RE: HARLOW STAGE 6 - AMENDMENTS TO CONSTRUCTION PLAN APPROVAL

RE: HARLOW STAGE 6 - CONSTRUCTION PLAN APPROVAL

**HARLOW ESTATE
STAGE 6
ROAD AND DRAINAGE
FACE PLAN - SHEET 1
WYNDHAM CITY COUNCIL
SIG GROUP**

CONSTRUCTION Drg No **309442CR200** Rev **2**

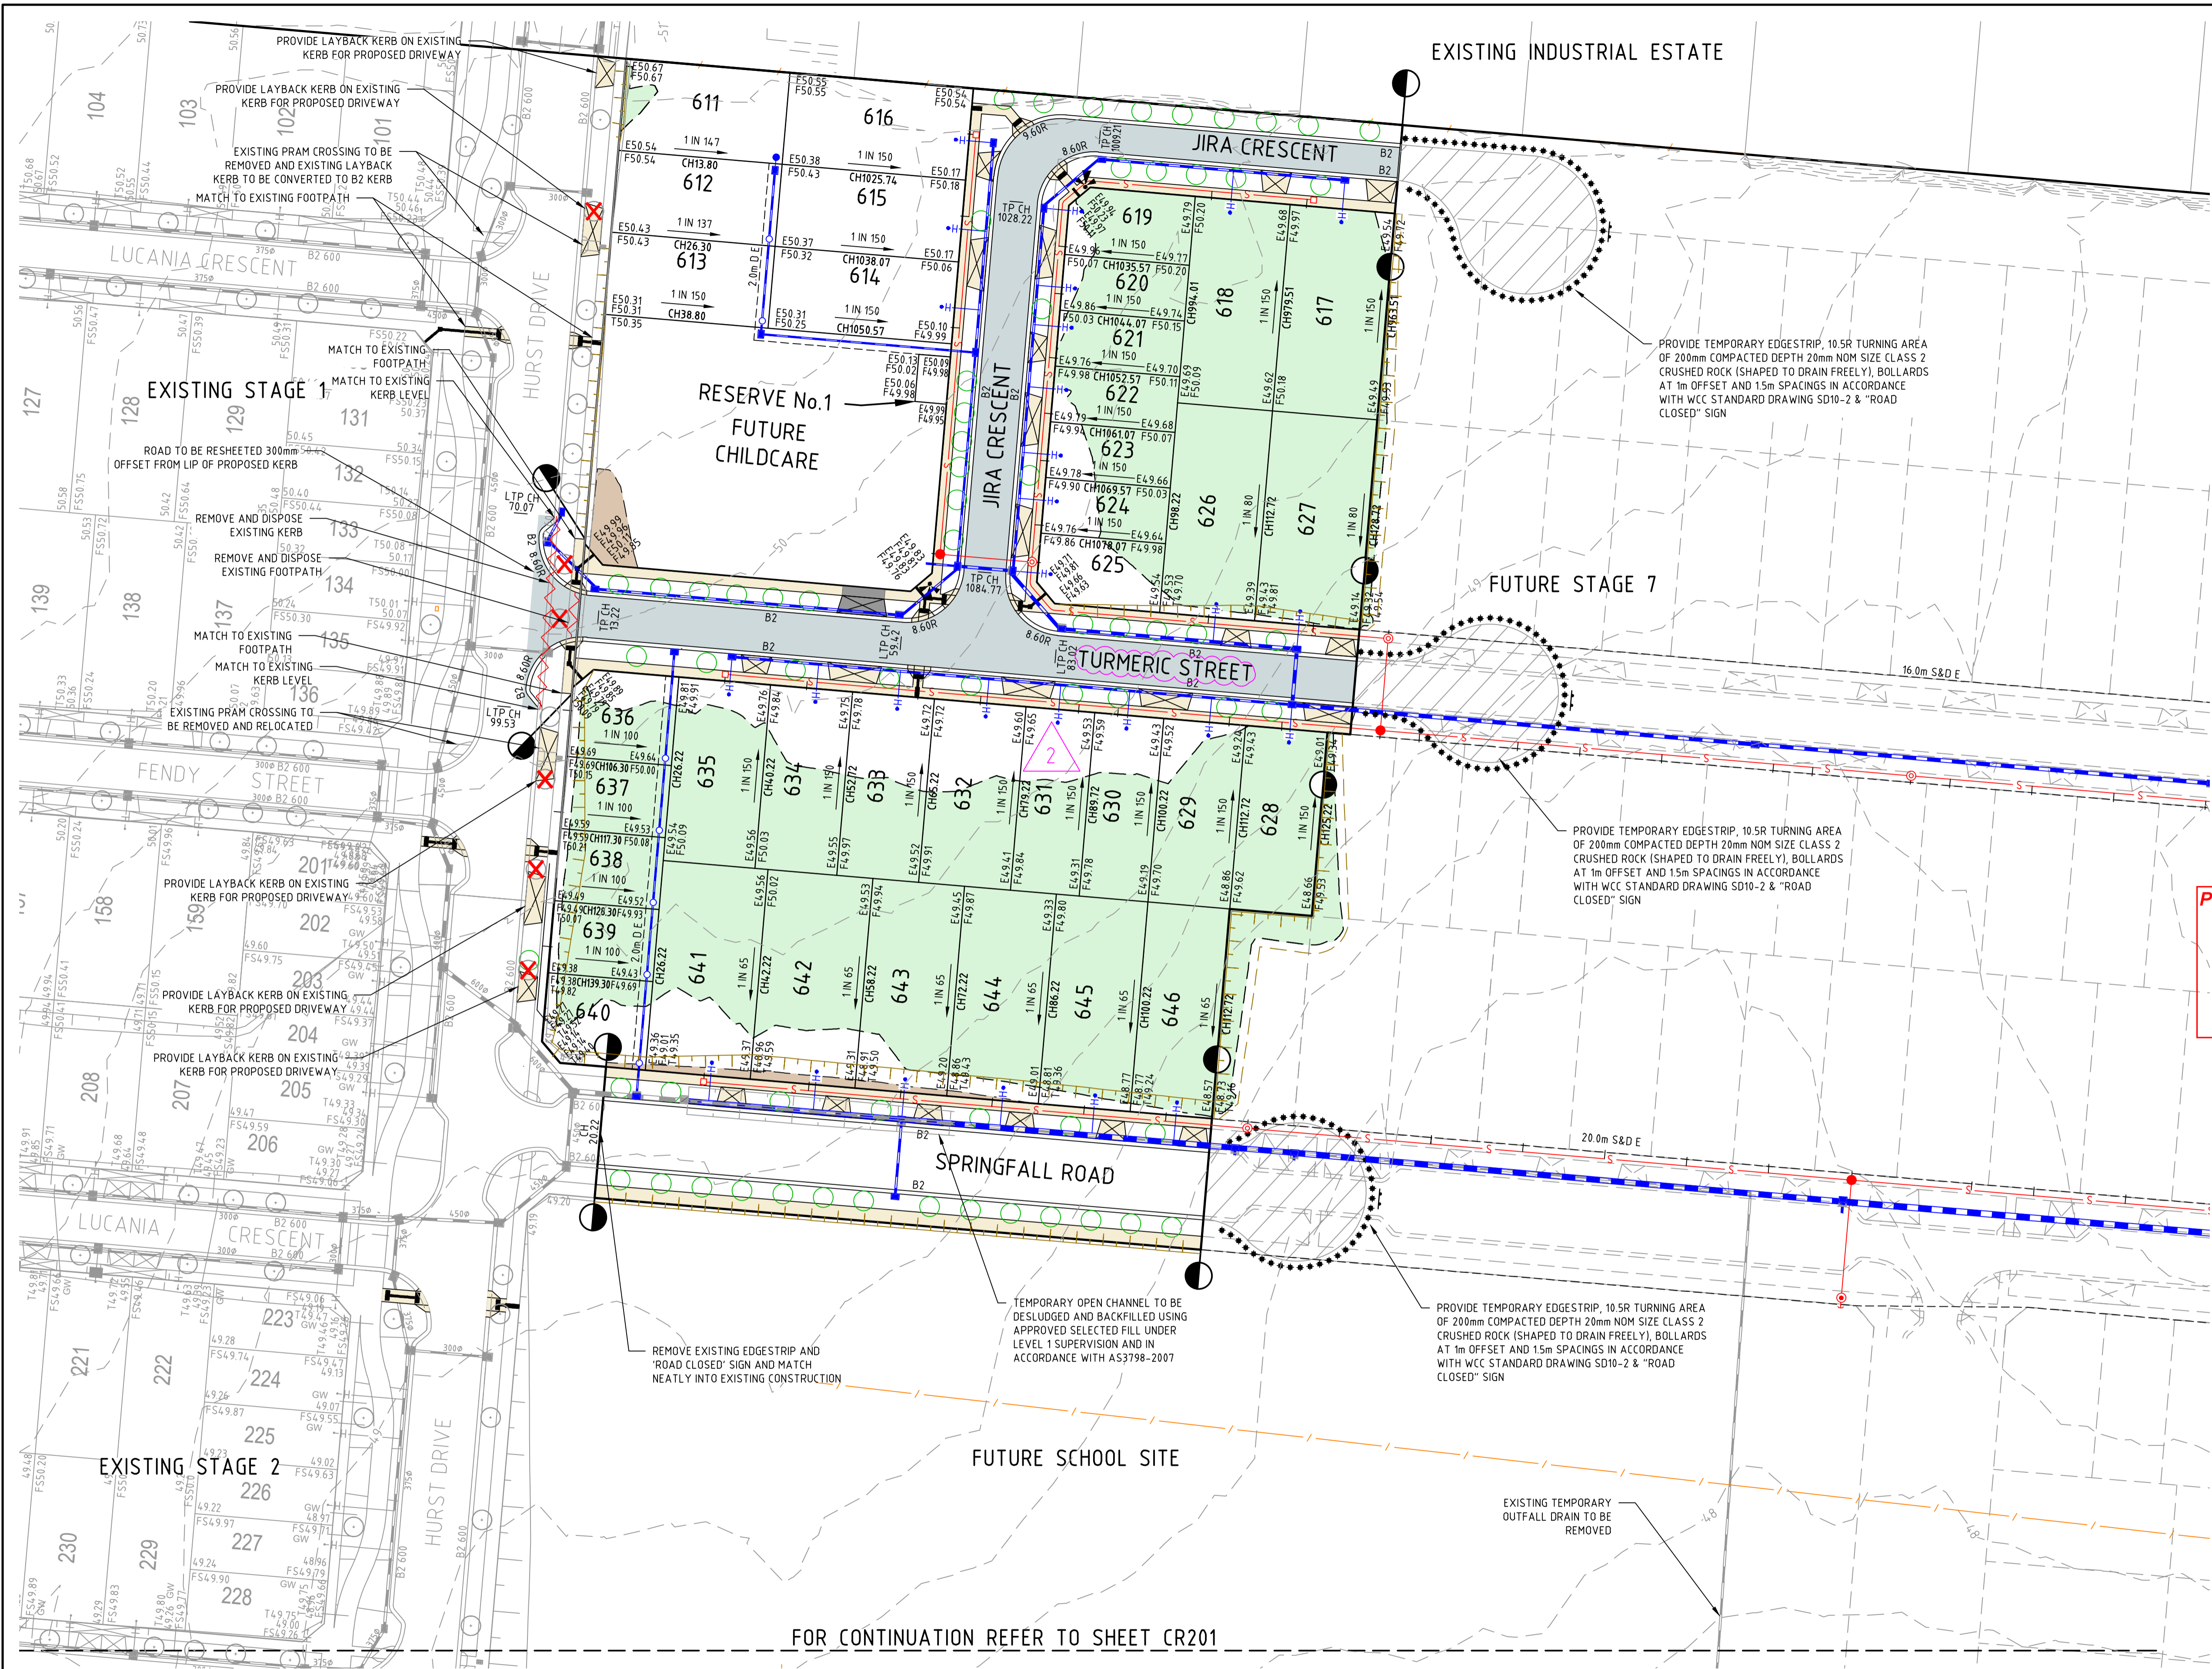
Rev	Amendments	Approved	Date
2	ROAD NAME AMENDED	G.K	01/10/25
1	INDUSTRIAL CROSSOVER ADDED	G.K	23/07/25
0	ISSUED FOR CONSTRUCTION	G.K	19/03/25
D	LOT NO & SWD ALIGNMENT AMENDED, BATTER ADDED	G.K	28/01/25
C	LOT LAYOUT, LEVELS & NOTES AMENDED; PRAM CROSSING & TGSIS ADDED	G.K	18/12/24
B	ISSUED FOR TENDER	G.K	16/12/24
A	ISSUED TO COUNCIL	G.K	01/11/24

CONSTRUCTION Drg No 309442CR202 Rev 2

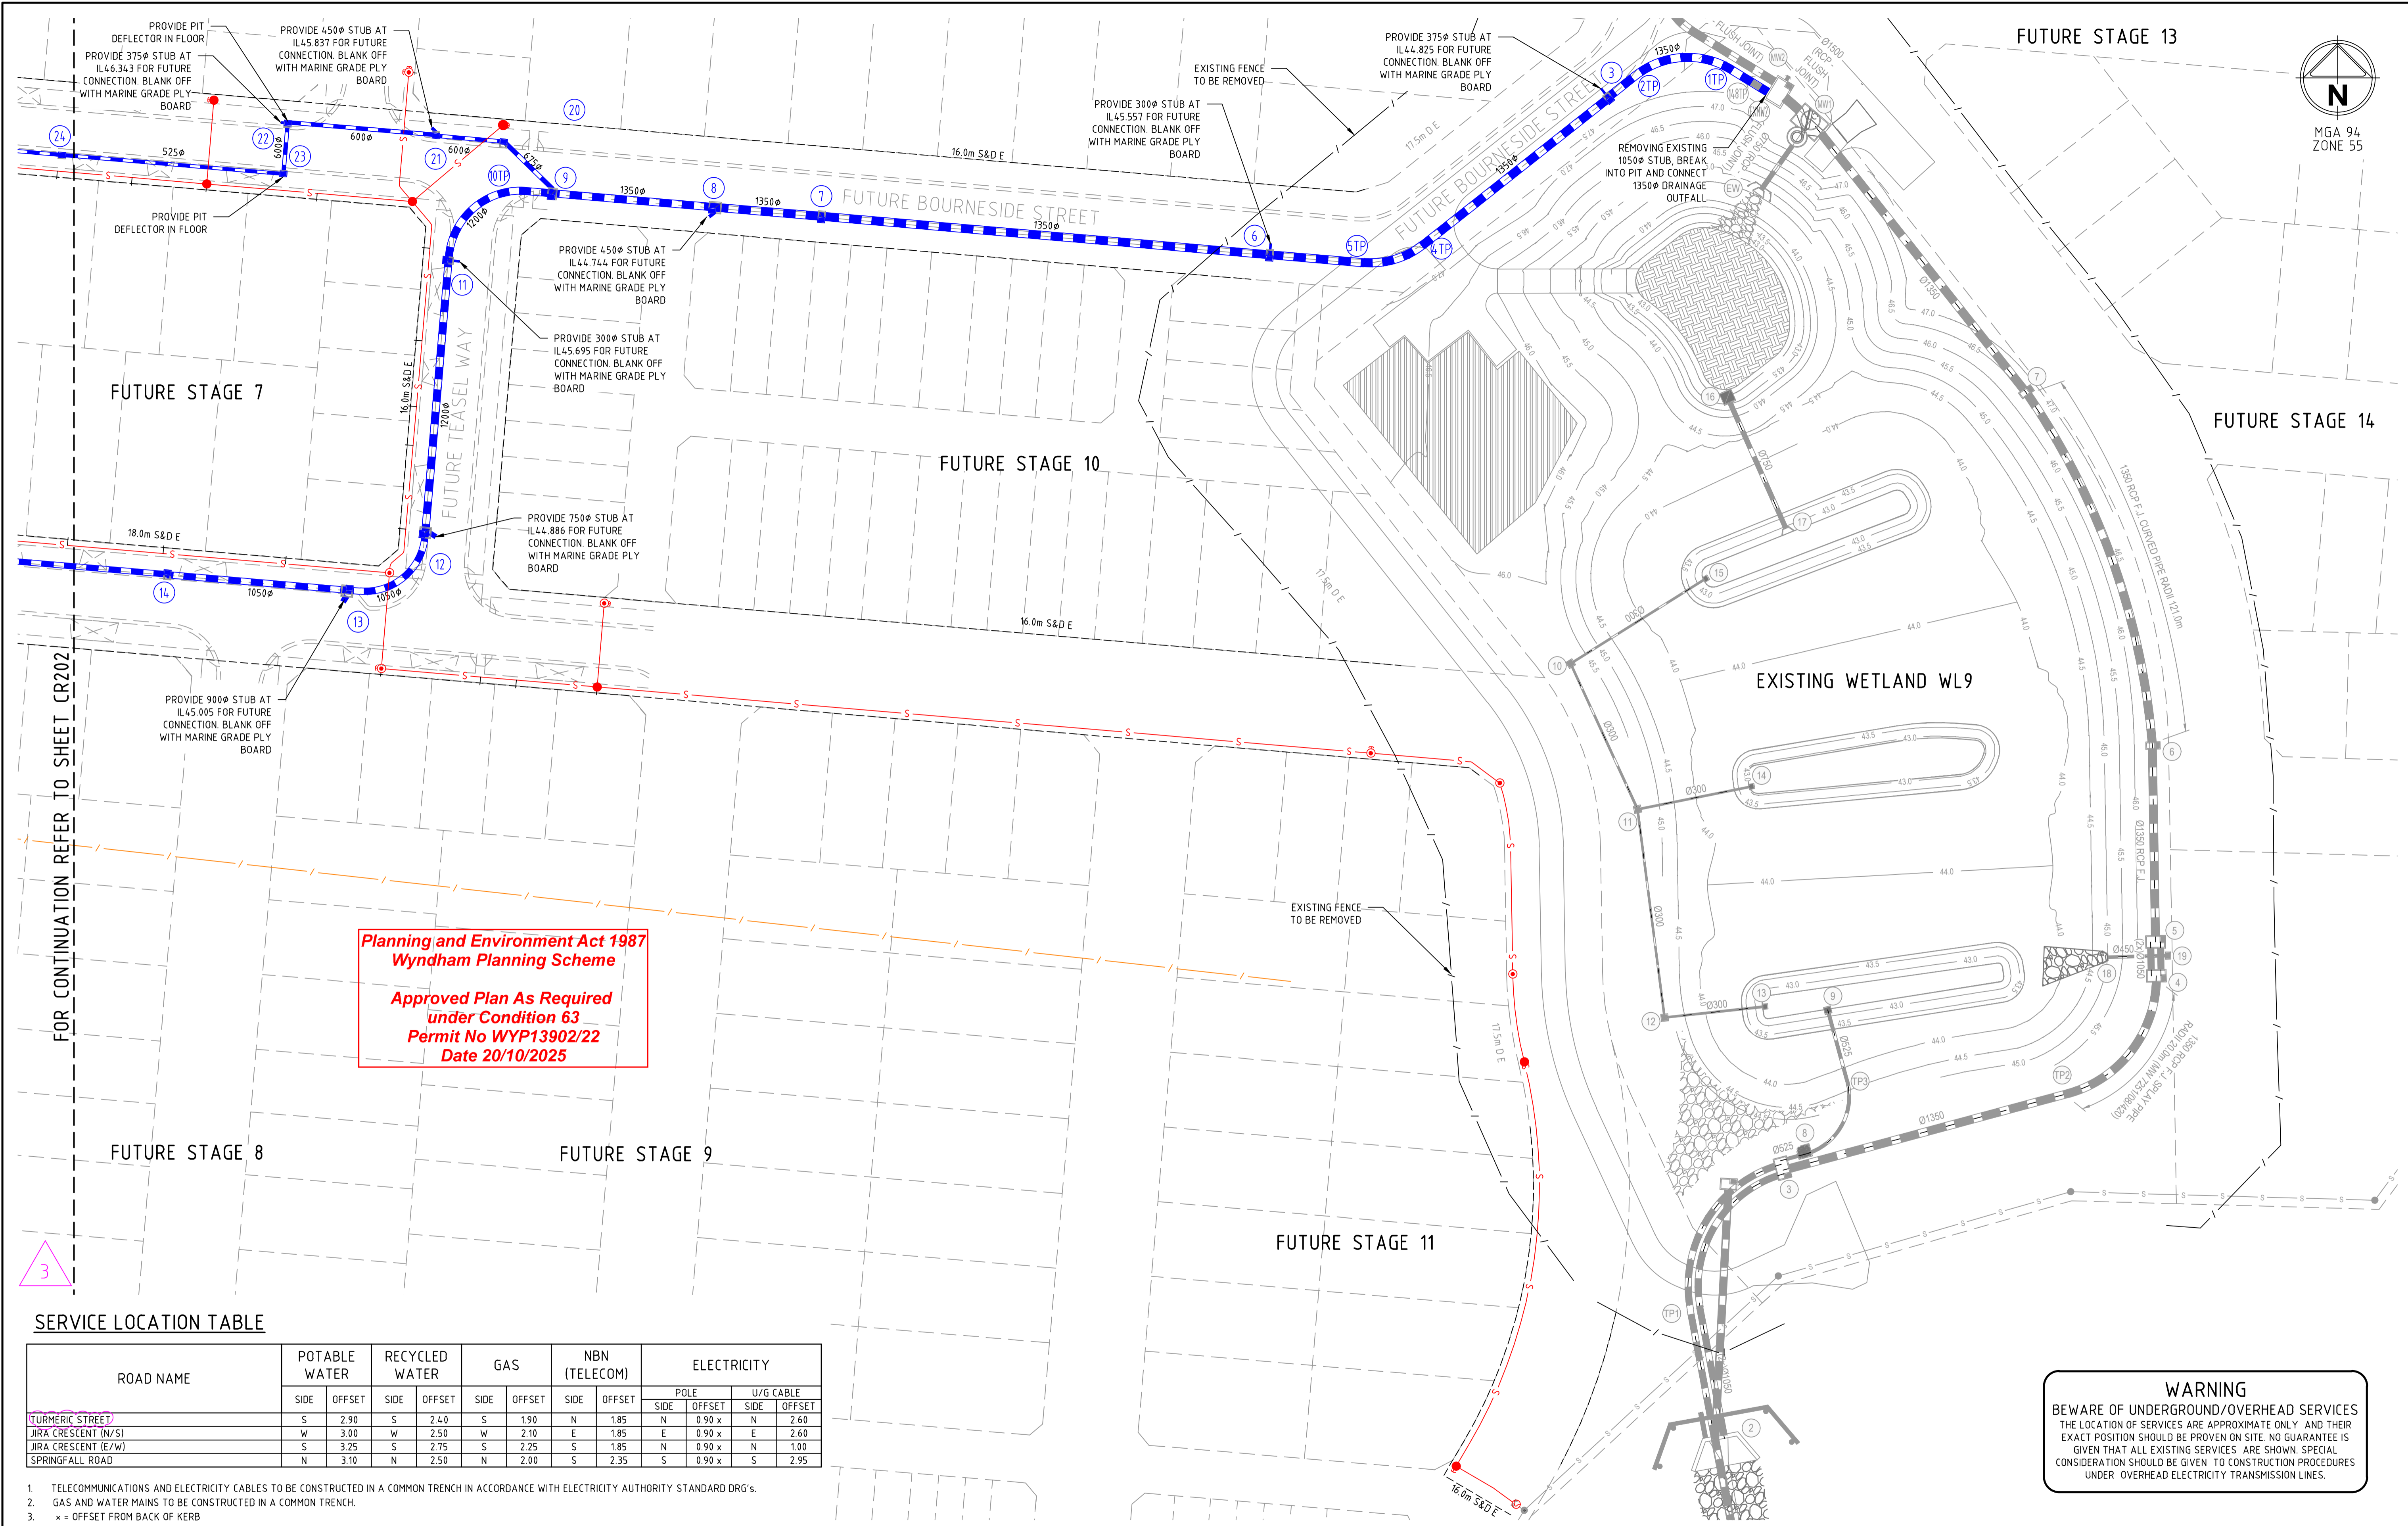
2	ROAD NAME AMENDED	G.K	01/10/25
1	SERVICE CONDUIT ADDED, PIT SIZE & PIT HAUNCHES AMENDED	G.K	23/07/25
0	ISSUED FOR CONSTRUCTION	G.K	19/03/25
D	NOTES, SWD SIZE & SWD ALIGNMENT AMENDED	G.K	28/01/25
C	LOT LAYOUT, SERVICES CONNECTIONS, NOTES, SWD & SEWER AMENDED; TREES & EXISTING TREES ADDED	G.K	18/12/24
B	ISSUED FOR TENDER	G.K	16/12/24
A	ISSUED TO COUNCIL	G.K	01/11/24
Rev	Amendments	Approved	Date
